DEVELOPMENT APPLICATION ASSESSMENT REPORT

Application Number:	DA2021/2490
----------------------------	-------------

Responsible Officer:	Thomas Prosser
Land to be developed (Address):	Lot 2 DP 1214257, 34 Plateau Road BILGOLA PLATEAU NSW 2107
Proposed Development:	Construction of a dwelling house
Zoning:	C4 Environmental Living
Development Permissible:	Yes
Existing Use Rights:	No
Consent Authority:	Northern Beaches Council
Land and Environment Court Action:	No
Owner:	Craig Lester Nicole Elizabeth Johnson
Applicant:	Craig Lester Nicole Elizabeth Johnson

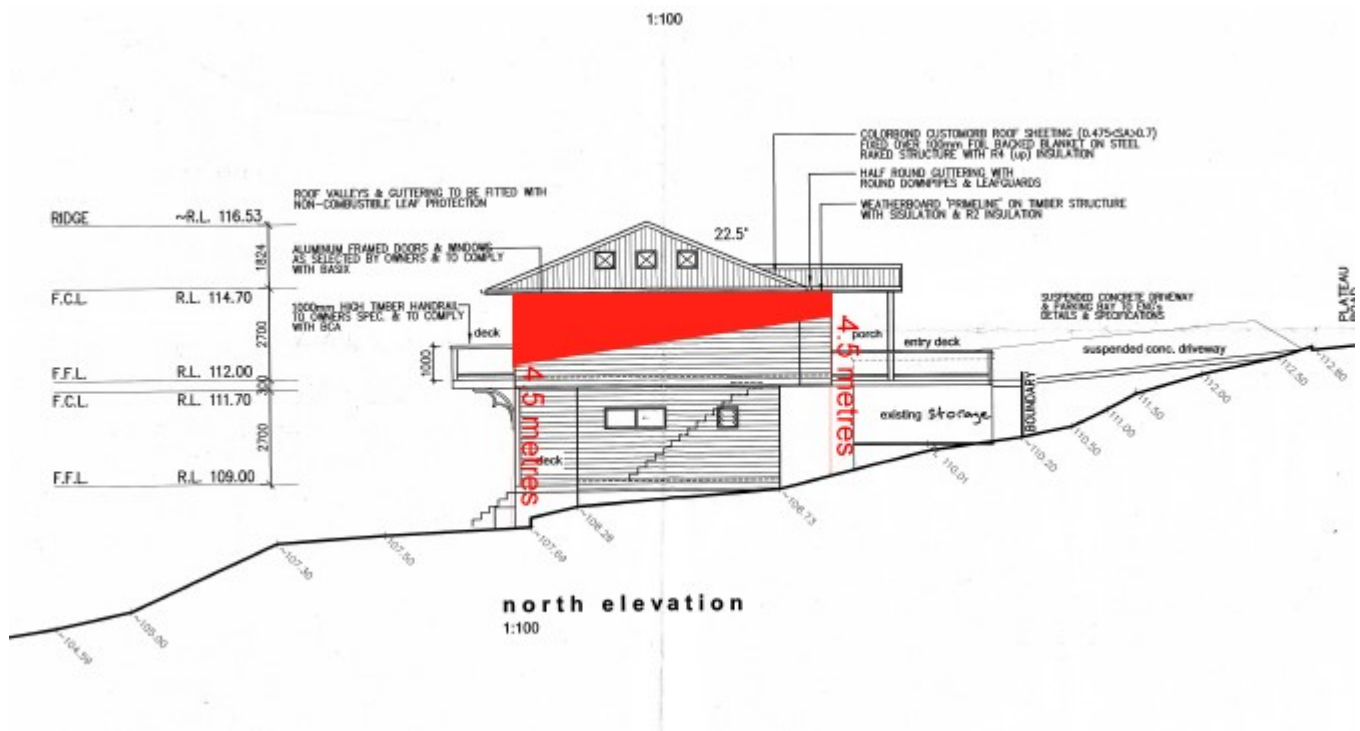
The proposed development encroaches the prescribed 4.5m building envelope control for a minor section at the northern elevation.

This is shown in the representation below:

Having regard to the above assessment, it is concluded that the proposed development is consistent with the relevant objectives of PLEP 2014 / P21DCP and the objectives specified in s1.3 of the Environmental Planning and Assessment Act, 1979. Accordingly, this assessment finds that the proposal is supported, subject to conditions, in this particular circumstance.
